DOCKETED	
Docket Number:	22-BSTD-03
Project Title:	2022 Field Verification and Diagnostic Testing OIR Proceeding
TN #:	247322
Document Title:	Hawthorne Investigation - Appendices
Description:	N/A
Filer:	Joe Loyer
Organization:	California Energy Commission
Submitter Role:	Commission Staff
Submission Date:	11/7/2022 3:31:47 PM
Docketed Date:	11/7/2022

CSLB Items of Complaint and Expert Findings

ITEMS OF COMPLAINT and FINDINGS BY EXPERT

Photo Identification of Complaint Item

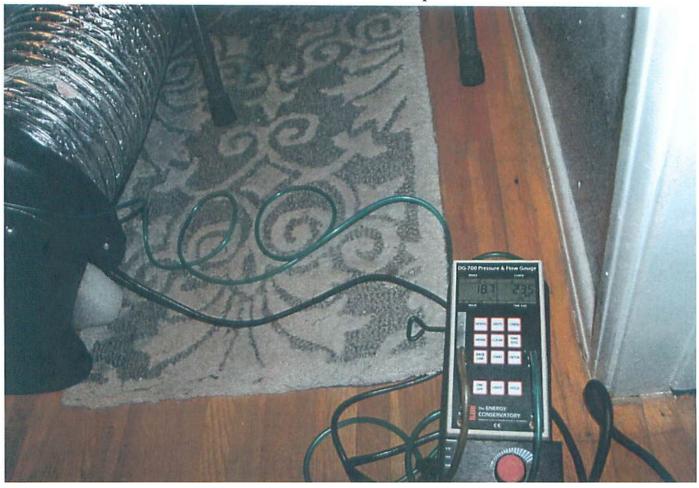
I. Item of complaint:
	Does not pass HERS testing.
2.	My observations: System appears to be sound, however after perfonning a HERS duct tightness test, airnow test, blower efficacy test, and refrigerant charge test, I find the system failed to pass two of the four required tests. (Afil1i111111 duct leakage allowed is JOOc/111, tested air duct leakage is 235 cfm, airflow required is 1750 cfm, measured airflow is 1484 cfin)

Complaint Item: Does not pass HERS testing.

Description: Duct tightness test failure @ 235 cfm leakage rate (minimum for this system is 100cfm)

7.	Method of correction: To zip tie all duct tenninations, perfonn a diagnostic test to locate air leaks in excess of 5% of system rated airflow as per CEC §150.0(m)(11) and increase the return air to a minimum of 1500 square inches as required by CEC §Table 150.0(d). (See anached supporting documents.)

Photo Identification of Complaint Item

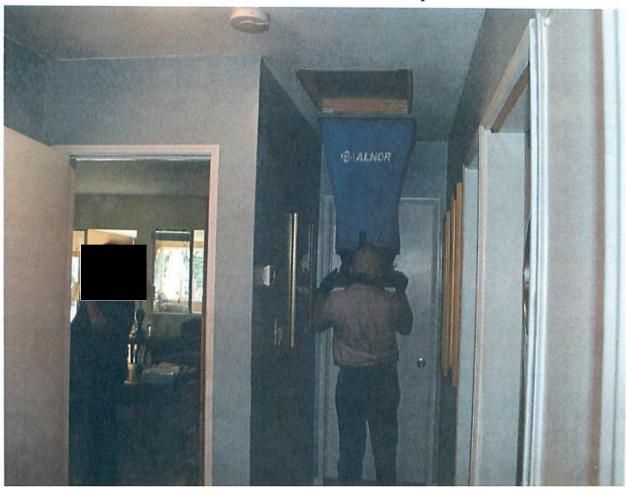
Complaint Item: Does not pass HERS testing.

Description: Hallway return 20 x 20 undergoing airflow testing using an Alnor EST 721 flow hood (approved for use by the State of California and calibrated 2018).

Photo Identification of Complaint Item

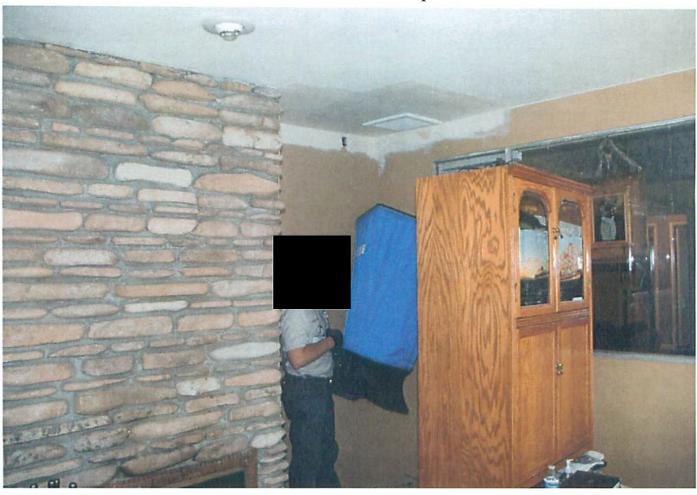
Complaint Item: Does not pass HERS testing

Description: There are two returns, one in the hallway measuring 20" x 20. • and the second one (shown here) is 12 " x 12". Together total is 1484 cfm (minimum for this system is 1750 cfm.)

Photo Identification of Complaint Item

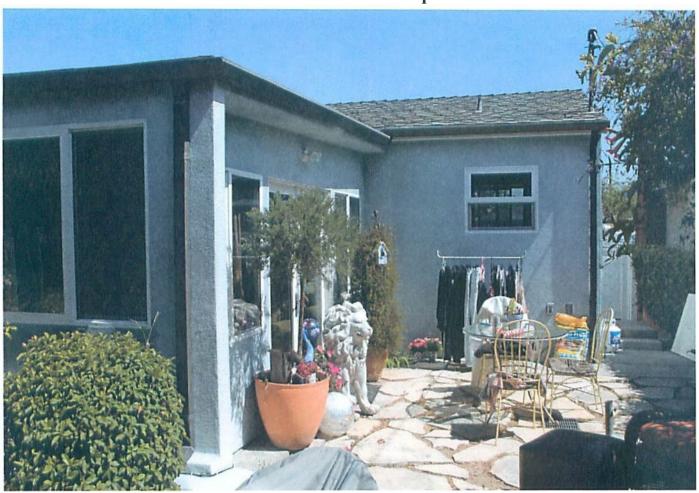
I.	Item of complaint:
	Sun room (enclosed patio) does not cool properly.
2.	My observations: Enclosed patio area is 285 square feet facing South exposure with considerable glass. No enclosed anic above, no notable South overhang.

Complaint Item: Sun room (enclosed patio) does not cool properly.

Description: South facing enclosed patio, south facing windows.

6.	Cause of defect: Contractor failed to install adequate supply air to this space to provide sufficient cooling.
7.	Method of correction: Install two IO" lined supply ducts (8" available inside duct diameter) with properly sized ceiling supply diffusers.

Photo Identification of Complaint Item

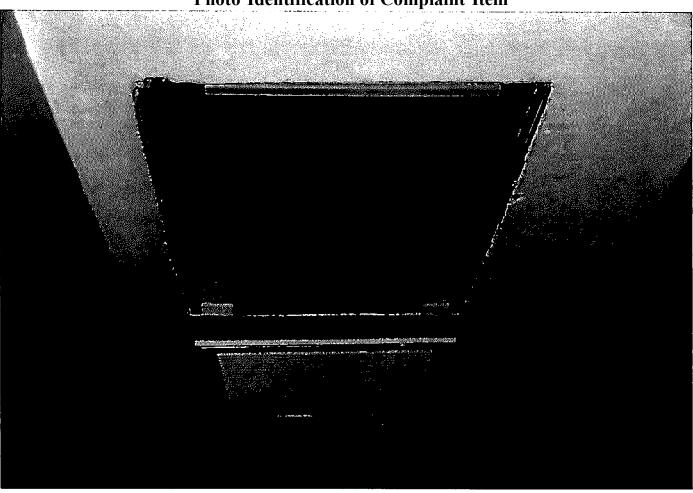
I.	 I. Item of complaint: Contractor did not properly repair and frame the crawl space opening, holes and areas 	where installation of unit
	was perfonned.

2.	2. My observations:	
	30 x 20 attic access was not finished properly. Does not meet the minimum opening	ng of30" x 22.
3.	3. Complaint item confonns to plans and specifications: N/A Yes	No_L

Description: Attic access cut in ceiling fails to have exterior molding and needs to be opened to meet state minimum of 30" x 22"

6.	6. Cause of defect: Contractor failed to increase attic access properly and install mitered molding.	
7.	7. Method of correction:	
	Cut and reframe attic access to a minimum Of 30" x 22 install mitered molding on th	ne exterior frame.
